Re: Preliminary Determination of Applicability
Farm Road Homes Project
55-65 Farm Road
Sherborn, MA

Expert Report of Scott Horsley

Subject: Revised GPC Comments for ZBA on the proposed 40B Farm Road Homes (approved by vote at GPC 9-13-23 meeting).

Figure 1 - Area of Impact - Lots 1 - 4

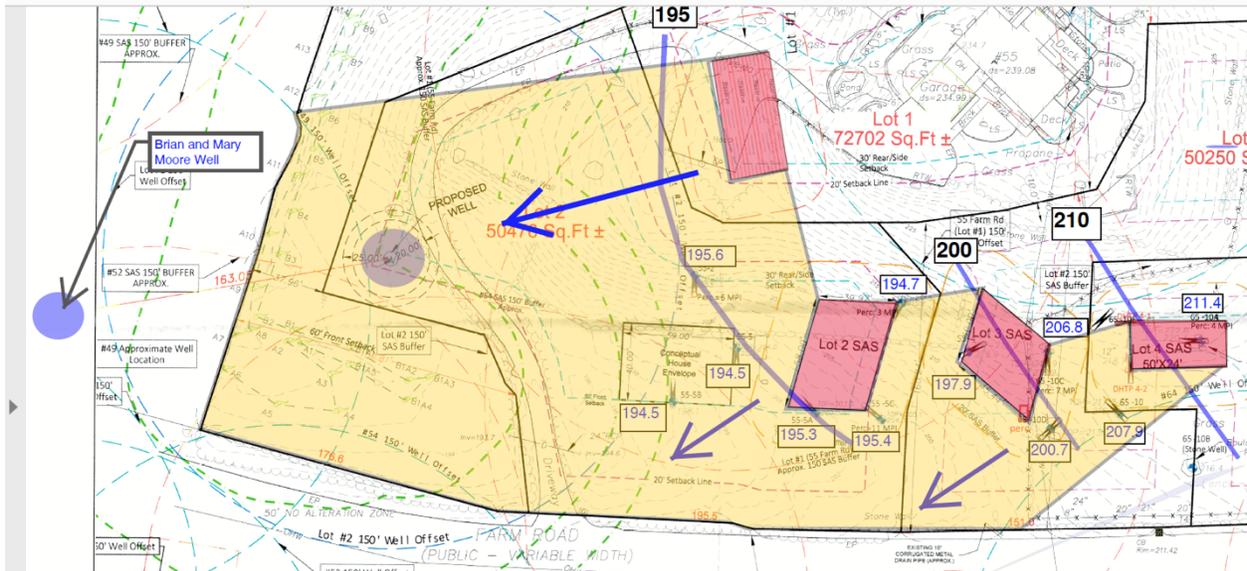
Based upon these groundwater flow directions I delineated two Areas of Impact (AOI). These include the AOI for lots 1, 2, 3, and 4 (see figure 1) and another AOI for the 40B Conceptual Overlay Plan prepared by Creative Land Development dated April 26, 2022 (see figure 2).

I then calculated the resulting nitrogen concentrations at the downgradient property boundary with your parcel (see Table 1). This analysis indicates that the proposed

wastewater discharges will result in nitrate-nitrogen concentrations in excess of the drinking water standard of 10 mg/liter at the property boundary and on your land. This analysis is conservative in that it does not account for fertilizer applications and stormwater runoff losses.

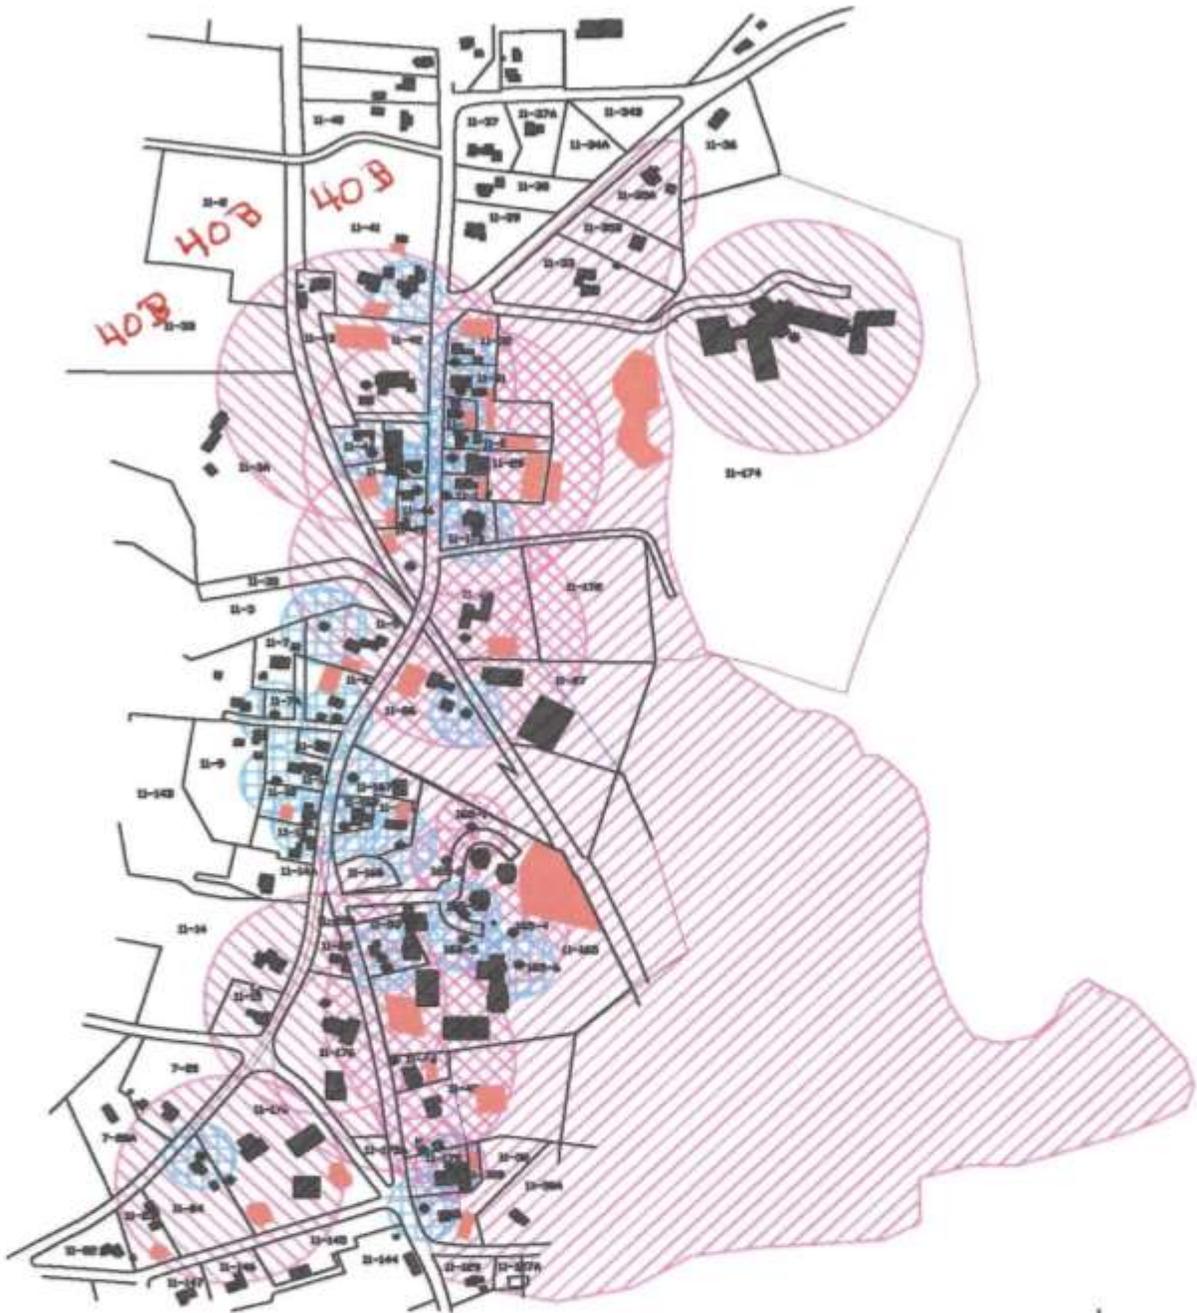
The two 40B sites intersect the PWS Zone 1 at the upper left of the map. The proposed PWS Zone 1 would overlap an existing Zone 1, a railroad, and a public road. The proposed sites are in the watershed for this already highly stressed area. Any failure of the 40B well or sewer systems would have an immediate impact on the neighbors either by loss of water capacity or water quality

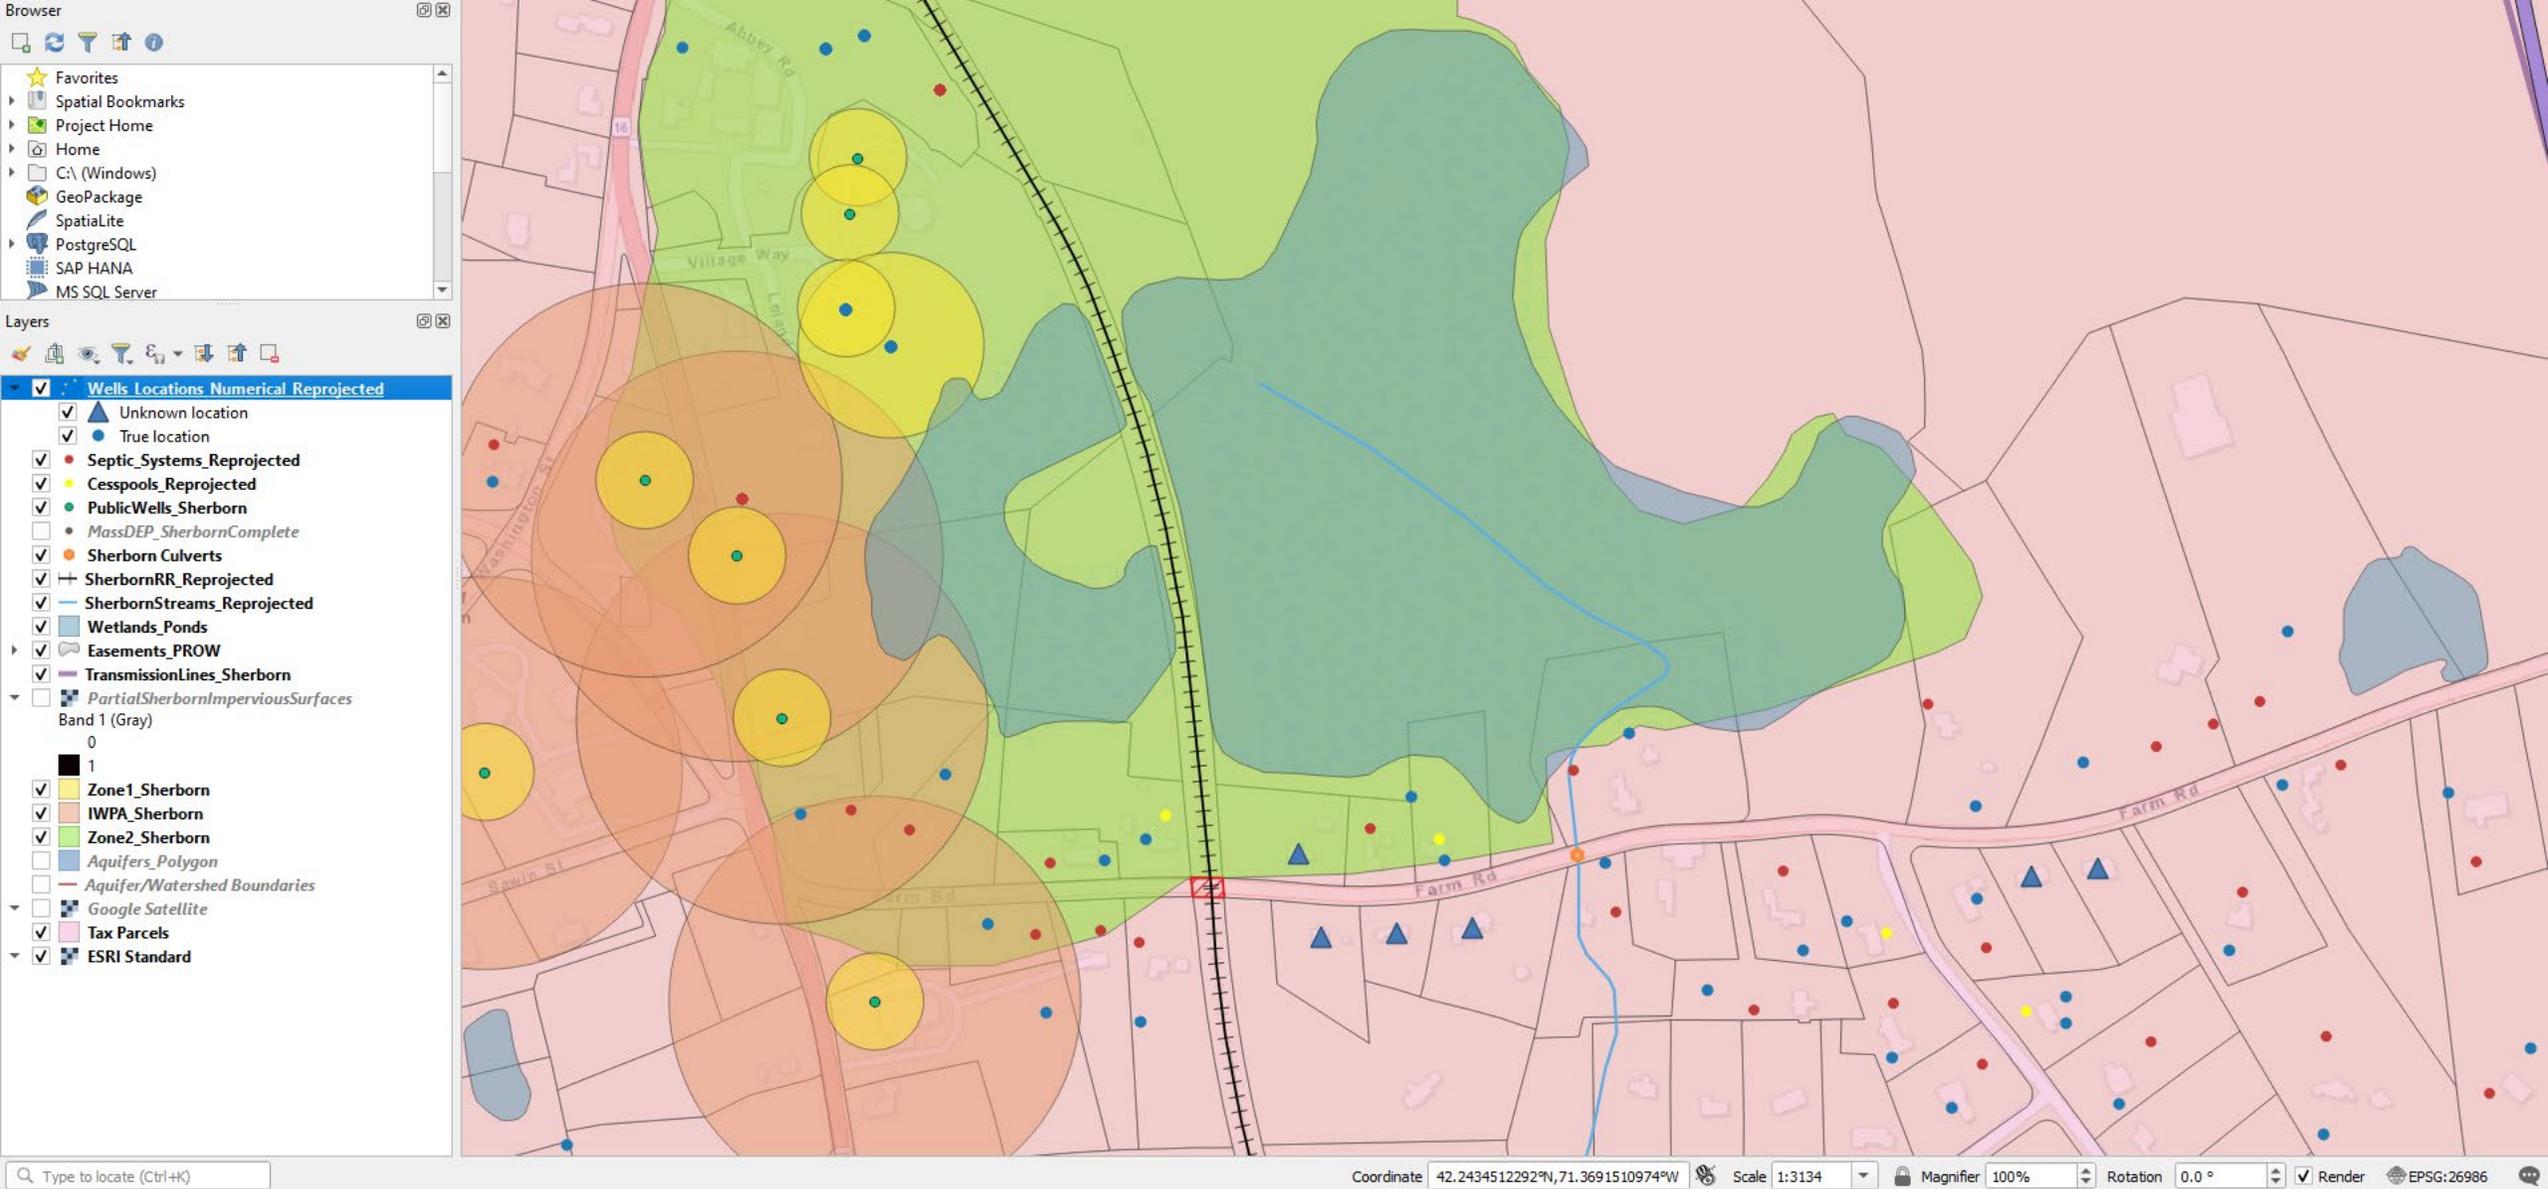
a. Seven private wells, located largely along the northeast border of the site, are planned to provide potable water for the 32-unit development, presumably to preclude the alternative installation of a fewer number of wells that would trigger regulation as public water supply wells by MassDEP (service of 25 or more residents per a single PWS well). This 7-well design is not particularly protective of the health of the new residents, as the Sherborn current BOH regulations only require “private” well water quality sampling/testing at the time of initial well installation, and nothing more in the way of water quality testing **at any time in the future**. MassDEP regulation of PWS wells often requires (dependent on total expected flows and population served) annual testing for certain common contaminants and would alert residents of any future public health risks. We suggest that the proximity of these seven wells to each other function as one or more public water supply well(s) and should be managed as such.

Figure 3. Proposed site plan (southeast section), above. Areal photo views, by year, from MassMapper, showing range in pond surface area along Farm Road.

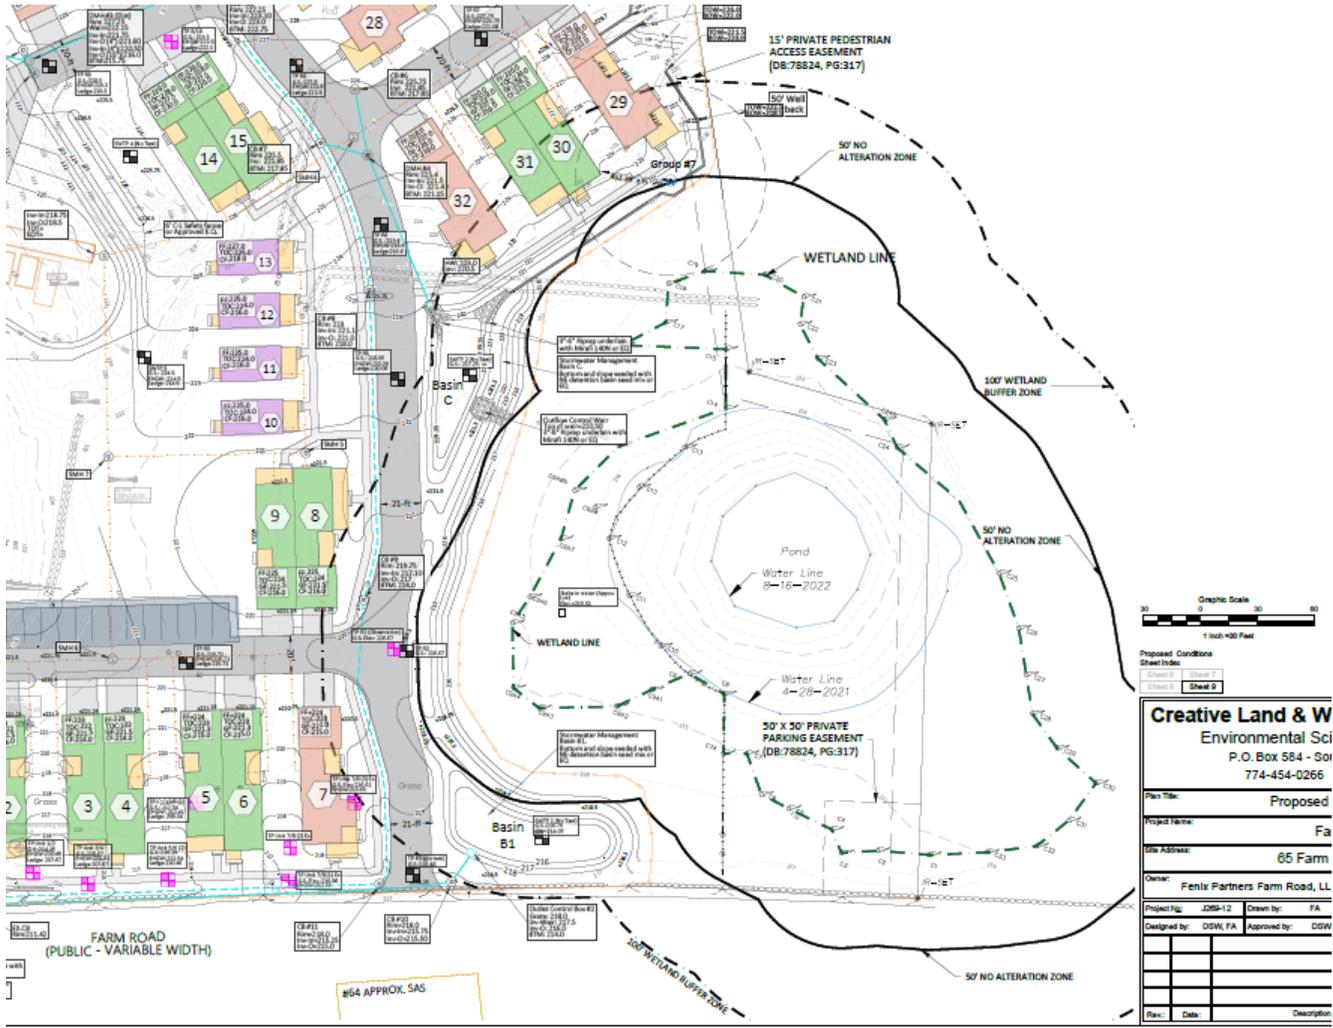
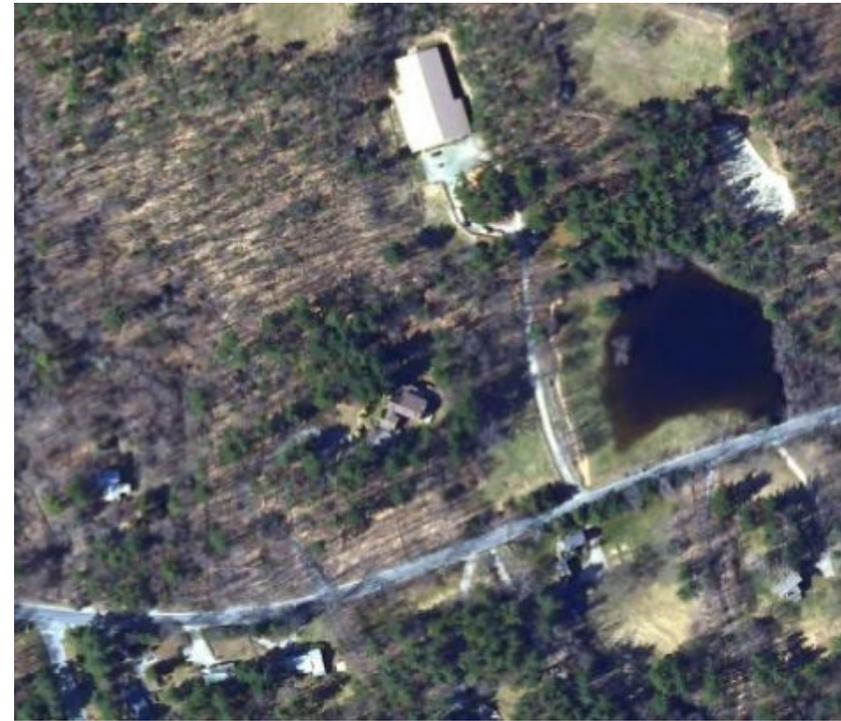
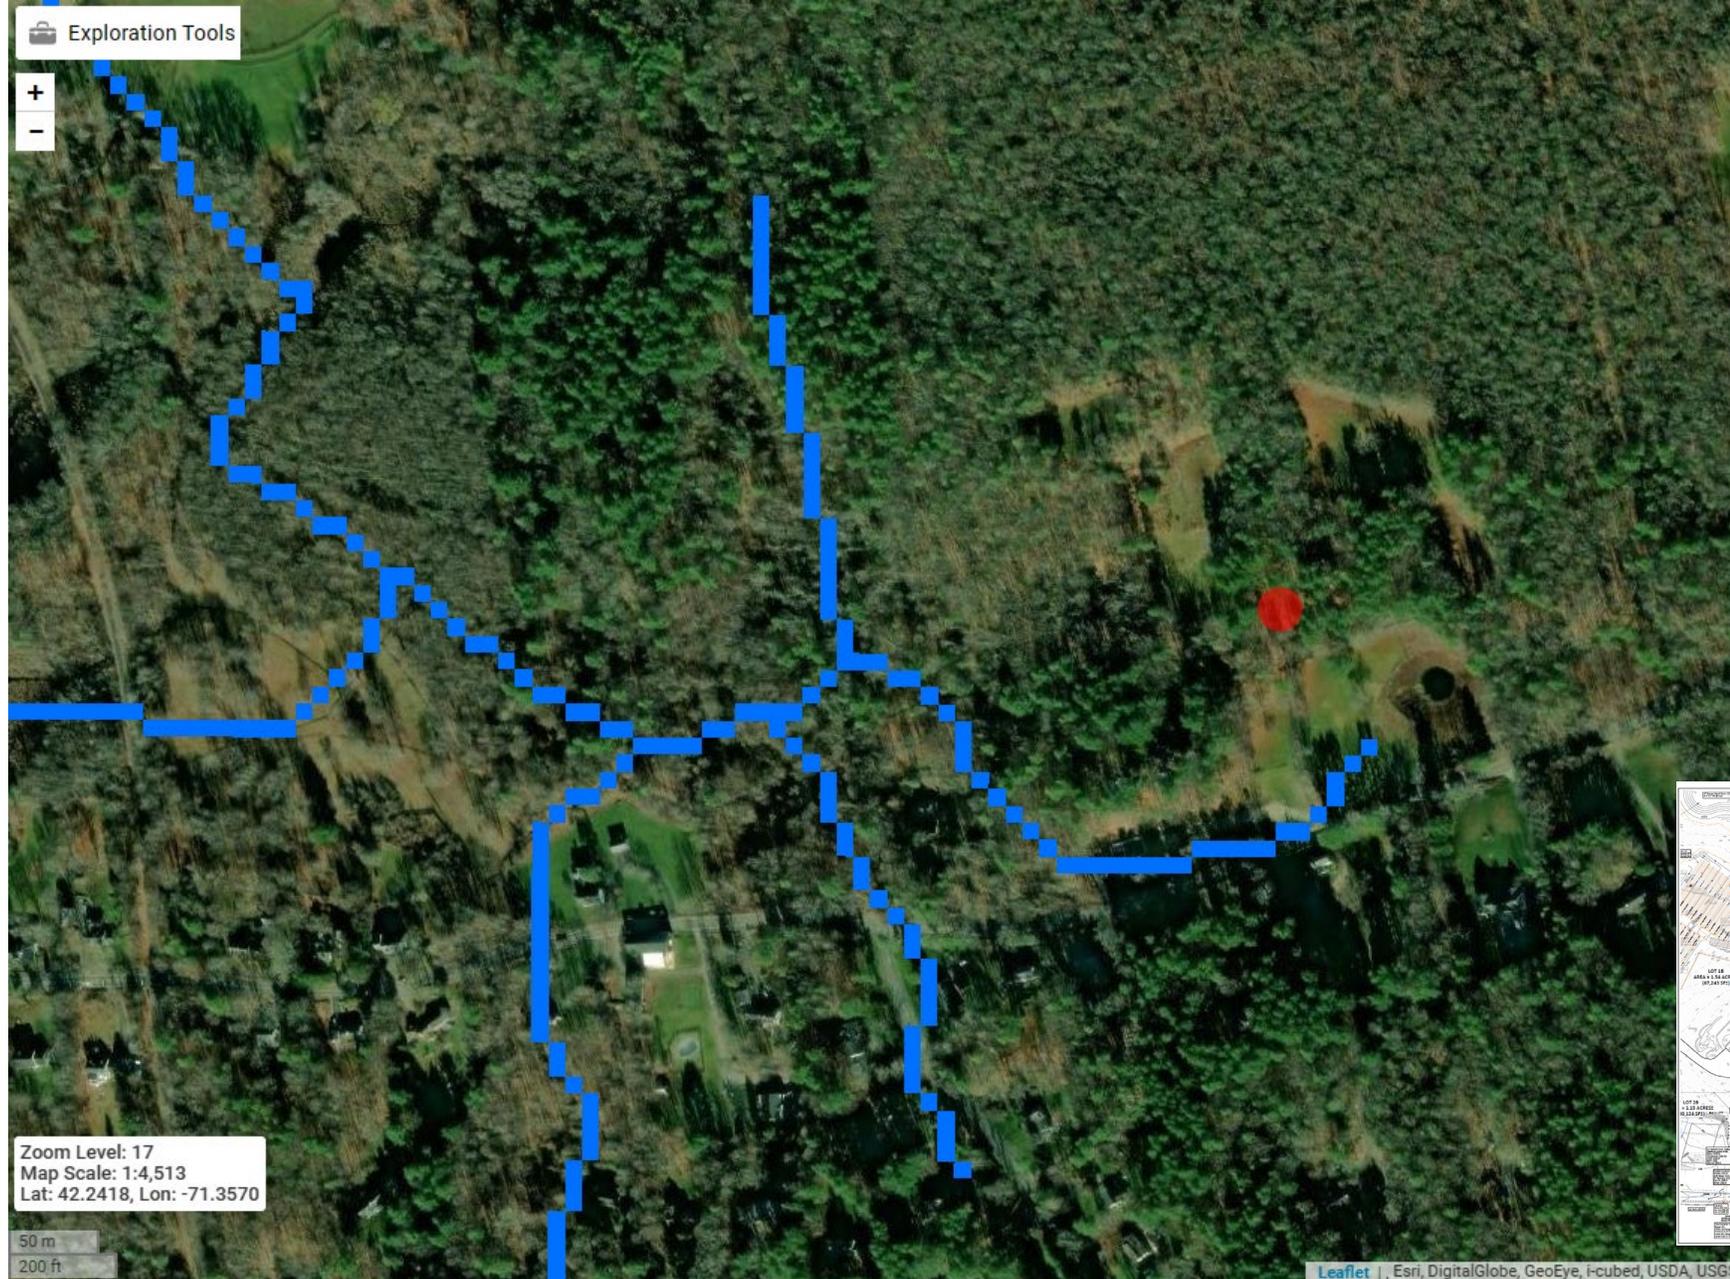
b. Another proposed stormwater basin is located downhill to the existing pond at the southeast end of the property. The pond already varies constantly in total size and depth based on average seasonal precipitation and groundwater levels (see **Figure 3**, with two examples of the change in pond size/area over the years). The new main entry road and potentially some housing units, as currently shown in the plan, may experience flooding, even with the proposed berm addition, if the pond expands significantly following a future storm event, and adding additional storm water to this area from the development's stormwater basin would worsen flood conditions. Future climate change trends will only exacerbate the extent of this flooding. A stormwater plan evaluation would need to account for the full drainage area tributary to the overall site and especially the existing pond.

Figure 4, USGS StreamStats surface water features. Water course with known flows west to Sewall Brook.

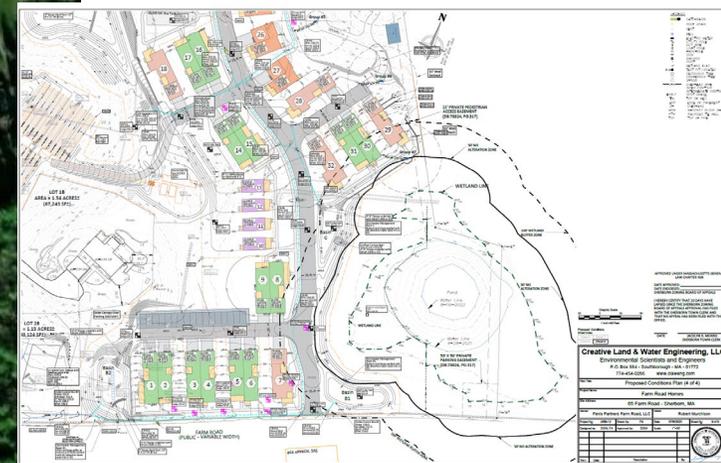
Moreover, the current USGS surface water resources map for this area (USGS StreamStats, <https://streamstats.usgs.gov/ss/>) depicts a water course feature on the site running along the southern edge, parallel to Farm Road, flowing west into a wetlands just downhill of this property, and eventually connecting to the larger Sewall Brook stream west of this site (see **Figure 4**). We request the stormwater plan review consultant hired by the ZBA take these known facts into consideration when determining the adequacy of the final stormwater management plan, and future stormwater flows that may impact neighboring properties and Farm Road itself; currently the Town of Sherborn is dealing with flooding issues on Farm Road adjacent to this site.
